Advisory Committee on Reactor Safeguards Full Committee Meeting December 4, 2025

Palisades Steam Generator Update - Operational Assessment

NRR/DNRL/NCSG

Figure 6-10: Model Indications and Detections vs. Actual Detections:
Eggcrate, Vertical Strap, and Freespan Axial ODSCC

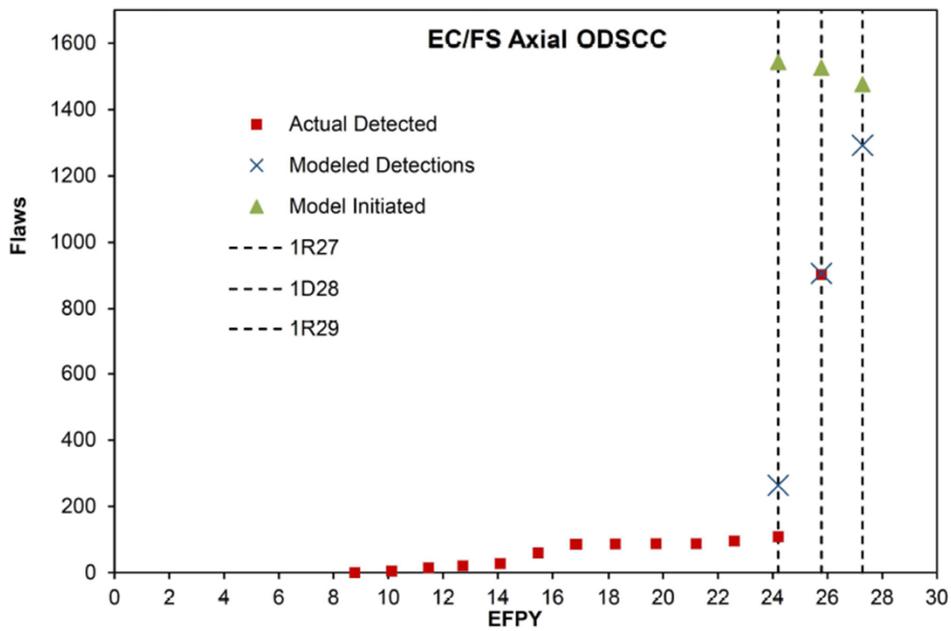
NRC Staff Comments, Cycle 29 OA

- Cycle 29 OA meets all acceptance criteria
- Small margin for meeting SIPC – ODSCC at eggcrate supports
- OA conservatively calculated average SCC growth rates by assuming all cracks were present at detection threshold and only grew during the last operating cycle (assuming cracking also occurred during the extended shutdown period decreases crack growth rate)
- OA assumes no benefits from chemical cleaning
- Clarification call with licensee on October 14, 2025
 - Obtain clarification on portions of Cycle 29 OA modeling
 - Upper tail growth and sensitivity analysis discussion
- Licensee's vendor is performing additional Cycle 29 OA sensitivity analyses; a new OA (Revision 3) will be issued
